Inventor : Carlos A. Hoyos )  
 Filed : 05/14/01 )  
 Serial No. : 09/854,764 )  
 For : TELECONTROL FOR REMOTE CONTROL )  
 OPERATION )  
 Examiner : N/A )  
 Art Unit : N/A )

PRELIMINARY AMENDMENT

**AMENDMENT AND RESPONSE**

TELECONTROL FOR REMOTE CONTROL OPERATION

CAMERA INTERFACE UNIT

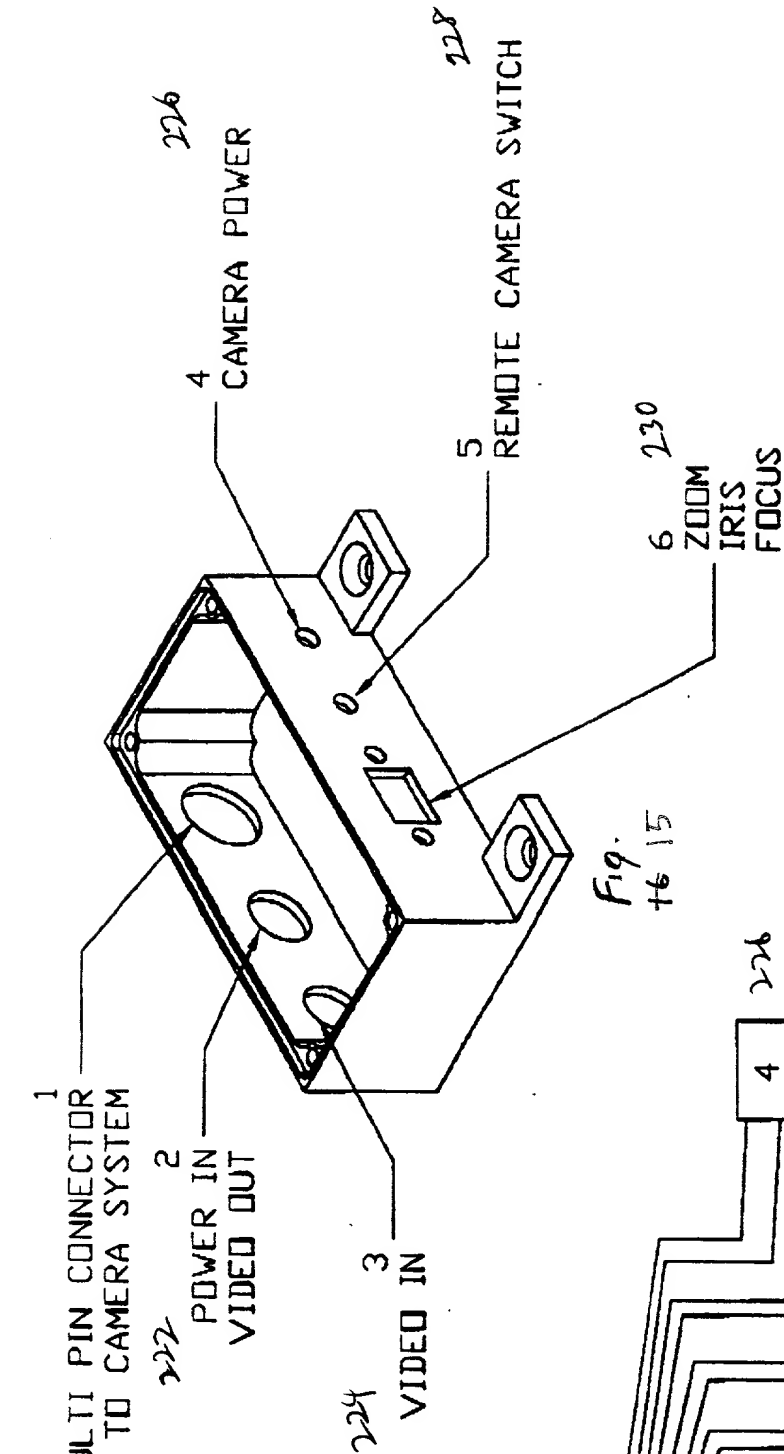
Applicant proposes that Fig. 15A-15F be deleted as redundant of original Fig. 13, and Fig. 18A-18D be deleted as redundant of original Fig. 16.

Applicant requests that original Fig. 16 be renumbered as Fig. 15 and original Fig. 17 be renumbered as Fig. 16 as shown in the attached proposed drawing sheets. Applicant also requests that original drawing sheets 1/12-9/12 and 11/12 be renumbered as 1/10-9/10 and 10/10, respectively, as shown in the attached proposed drawing sheets.

On page 5, replace paragraph [0027] with "Fig. 15 is an isometric view of a camera interface unit according to the present invention."

On page 12, replace paragraph [0053] with "Referring now to Fig. 15, the box of camera interface unit 134 includes opening for multi-pin connector 220, power in/video out 222, video in 224, camera power 226, remote camera switch 228, and zoom/iris/focus 230."

Referring now to Fig. 15 [16], the box of camera interface unit 134 includes opening for multi-pin connector 220, power in/video out 222, video in 224, camera power 226, remote camera switch 228, and zoom/iris/focus 230.
